STATE OF TENNESSEE
TENNESSEE DEPARTMENT OF CORRECTION

QUESTIONS AND COMMENTS

RFI 8025 - Pre-Bid Conference and Site Visit - Satellite TV at

DATE: May 22, 2014

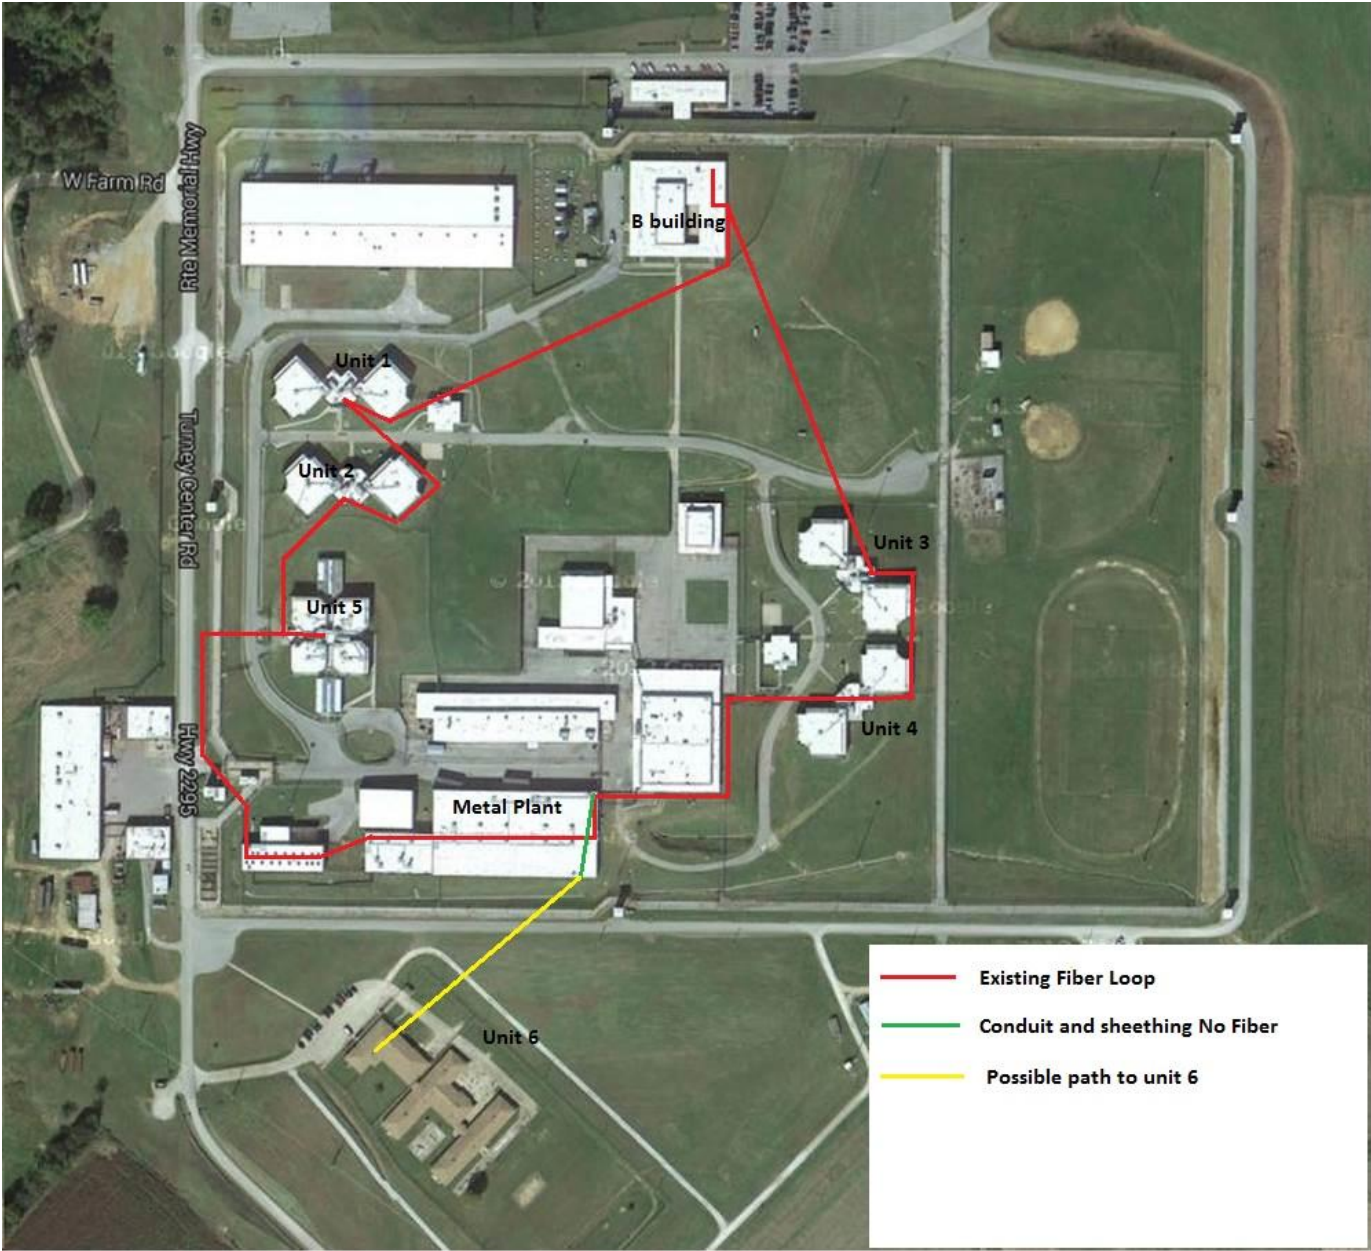
QUESTION / COMMENT	STATE RESPONSE
<p>1 What is the distance that the Vendor is responsible for putting in the conduit/fiber.....through the perimeter/road and through the parking lot of Unit 6?</p>	<p>The distance with conduit sleeve no fiber installed inside J building is 110' (green on map). The building wall to unit 6 is approximately 555 feet (Yellow). Footage is based on direct path.</p>
<p>2 We need a diagram of the routing of the fiber to each building and the distance in feet from building to building. All building should be identified by their unit # or name. This is needed so we can design the fiber system and identify the proper transmitter and or receivers to place. A google earth such as the one at the end of this email (and attached) or one that is one hand will suffice. They could just identify the buildings and make a list of distances in between each but we do need the routing drawn out.</p>	<p>B to 1 1110' B to 2 1550' B to J 3350' B to 3 4180' B to 4 4620' B to 5 2000'</p> <p>Up to 2 strands of single mode fiber have been provided per unit.</p> <p>These distances are provided from the original fiber install. The Attachment A- Map is labeled with building designation.</p>

QUESTION / COMMENT	STATE RESPONSE
<p>4 On the "Line_Items" pricing to be submitted.</p> <p>Item 1 is the Satellite Dish Television service and all channels being provided and monthly service associated with the RFP including the training. Vendor would own all equipment in Item 1.</p> <p>Item 2 is all Fiber installation work including effort and material to connect Unit 6 as well as all splicing and fiber work including transmitter and receivers (including requested spares) that tie all units together. TCIX would own all equipment and material in items 2.</p> <p>Are the above statements correct?</p>	<p>Correct</p>
<p>5 Since the "drop Areas list totals 1,285 there are actually a maximum and drop count of 1,285 to be used in this FRP process? Please verify.</p>	<p>1285 is the maximum amount of drops. This includes the single drop in B Building.</p>
<p>6 Could we get a cable & fiber layout map showing path, footages, fiber counts, termination points along with RG6 wiring, with longest drop within units and type of cabling?</p> <ul style="list-style-type: none"> On the above map could the best proposed route of fiber cable from the metal building to unit 6 along with footage of conduit needs be placed on it ? 	<p>A rough drawing of the basic distribution has been provided of the units, Attachment B. The maximum drop distance is 110' in each pod. The configuration in the housing units will change based upon the winning bidders recommendations. Since anything beyond the distribution point will be the states responsibility to correct signal issues.</p> <p>Best proposed path for fiber from metal plant to unit 6 is listed on the attached map.</p>
